Descripción general: El nuevo arnés en T FTI-STP1 requiere modificaciones para su uso en aplicaciones de transmisión automática (AT).

FTI-STP1: Notas de instalación y configuración

MODIFICACIÓN REQUERIDA PARA APLICACIONES DE TRANSMISIÓN AUTOMÁTICA ÚNICAMENTE

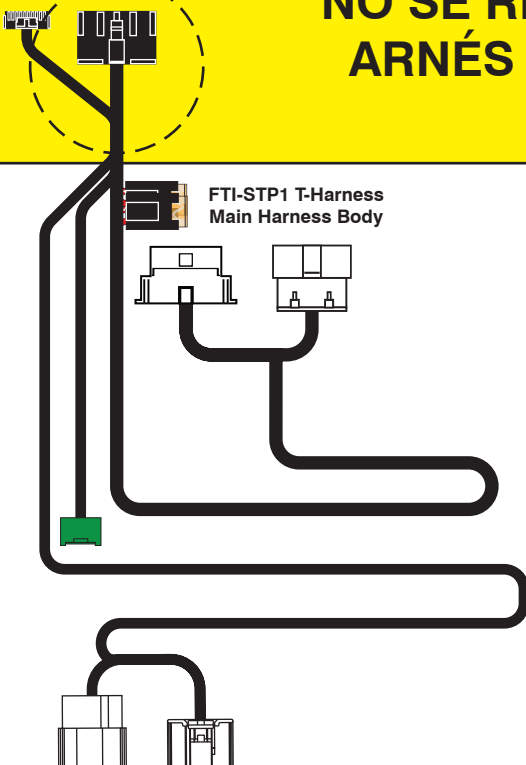
Problema: El arnés en T FTI-STP1 ha sido diseñado para ser compatible con AT (transmisión automática) y MT (transmisión manual), pero debido a una supervisión de la producción, el mecanismo de selección se estableció por defecto en el modo MT.

El uso de un arnés configurado para una aplicación MT, en un vehículo equipado con AT, podría provocar daños en el módulo del vehículo. Se recomienda que el arnés vuelva al modo AT antes de instalarlo en vehículos equipados con transmisión automática.

Corrección: Localice el cable rojo/negro (+ embrague) provisto en el conector CN1 del conjunto del arnés principal. Corte el cable rojo / negro, ya sea al ras del conector CN1 o dejando suficiente cable expuesto para que pueda aislar y asegure los extremos del alambre que quedan después del corte. Aísle cada uno de los extremos restantes del cable rojo/negro y asegúrelos para evitar cualquier posibilidad de cortocircuito.

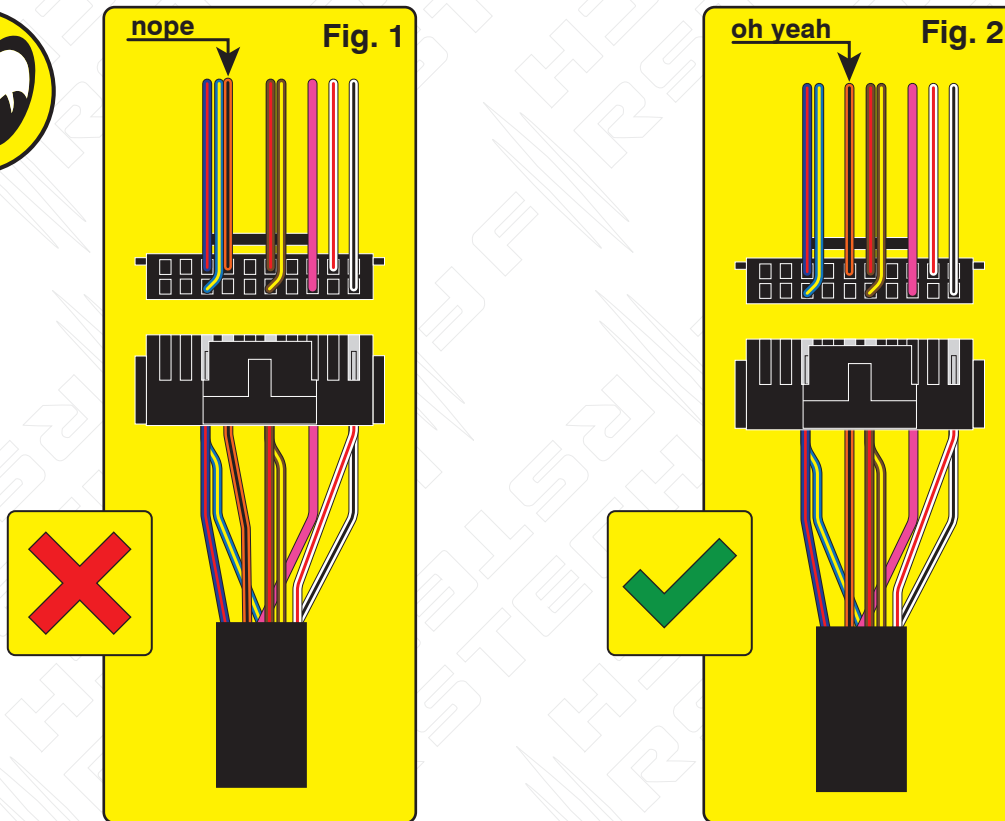
Overview: Production error; immobilizer wire (orange/black) in pin position #4 instead of pin position #5. Although an effort to correct the issue was made, some quantity of harnesses did get shipped before the issue was spotted. We are advising to inspect the harness BLADE connector before attempting to install the harness and program the module.

Issue: Module fails to program to vehicle, will not allow the vehicle to be remote started.

Correction: Step 1.) Locate the orange/black wire and confirm whether it is positioned as illustrated in Fig. 1 or Fig. 2. If the wire is as illustrated in Fig.1, proceed with Step 2 through 5 and complete the repair procedure outlined, if the wire is as illustrated in Fig. 2, correction is not necessary, proceed with harness installation and module programming.

Step 2.) Using a pick, lightly depress the catch that secures the terminal in the housing then remove the wire and terminal from the housing.

Step 3.) Using a fine tip razor or utility knife, insert the blade beneath the terminal catch and raise it slightly, so that it can be reused to secure the terminal when reinserted into the BLADE connector housing.

Step 4.) Refer to Fig. 2 for correct position of the orange/black wire (next to brown/red) then reinsert the terminal, pressing lightly until the catch 'snaps' into place, securing the terminal in the connector housing.

Step 5.) The repair is complete, proceed with installation and programming.
